ECO No. N0012

NABU ENGINEERING CHANGE ORDER

PRODUCT LINE	AFFECTED ITEM(S)	RELATED ECO
1600	MAIN LOGIC BOARD 90000420	-

To modify the floppy disk interface to add write precompensation circuitry.

SHEET 2

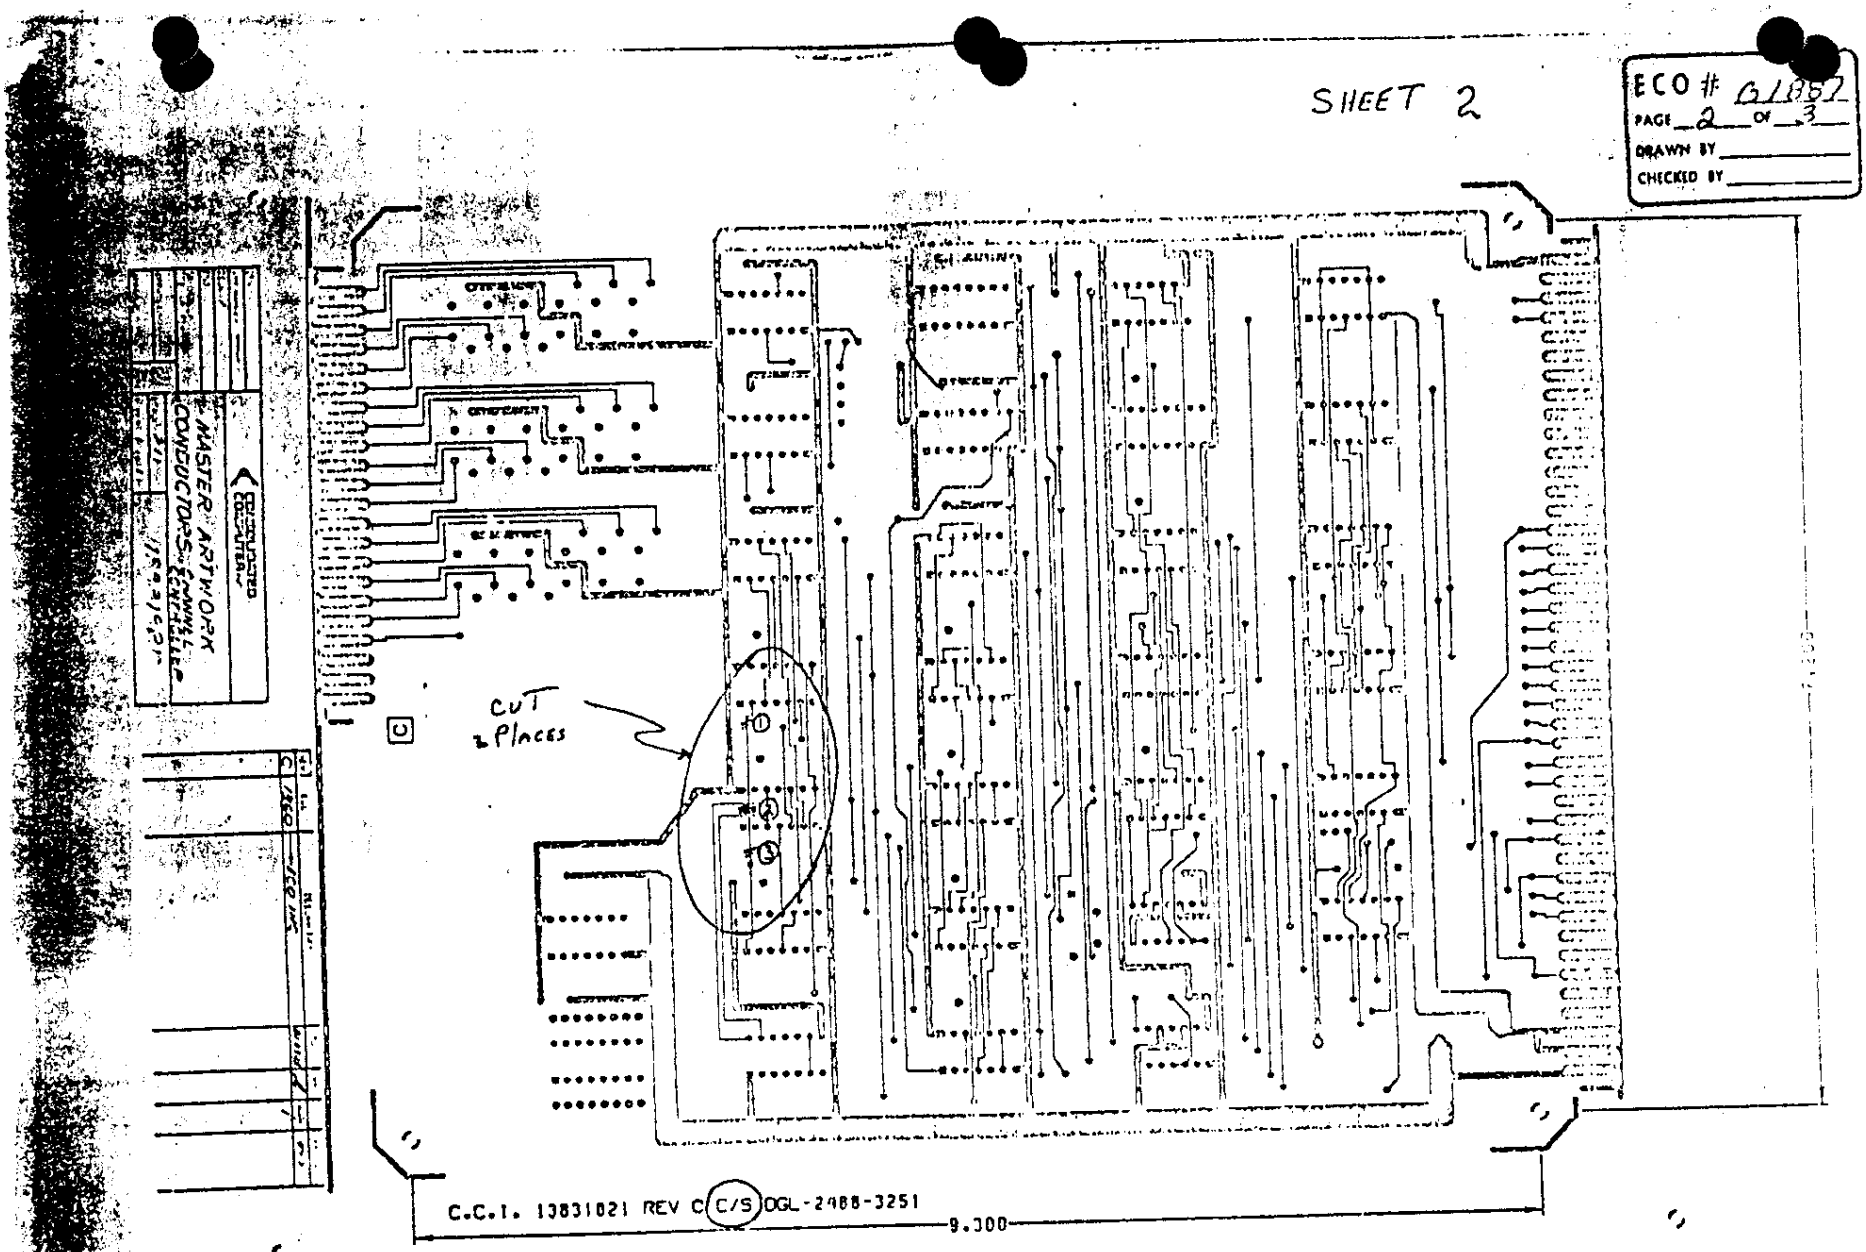
ISOLATE FOIL SHORT TO REFLECT LOGIC.

REWORK: ALL REV D PWA IN PLANT AND MANUFACTURERS Follow 1) REMOVE IC at location C2 IF ALREADY INSTALL. 2) REFER TO SHEET 2 AND CUT TRACK AS SHOWN. (3 PLACES ON COMPONENT SIDE) 3) USING 26 AWG 2 IN WIRE P/N 904/9000 CONNECT D2-2 TO FEEDTHROUGH CLOSED TO CAPACITOR C24 (SEE SHEET 3) 4) REINSTALL IC IN REGARDS TO STEP 1
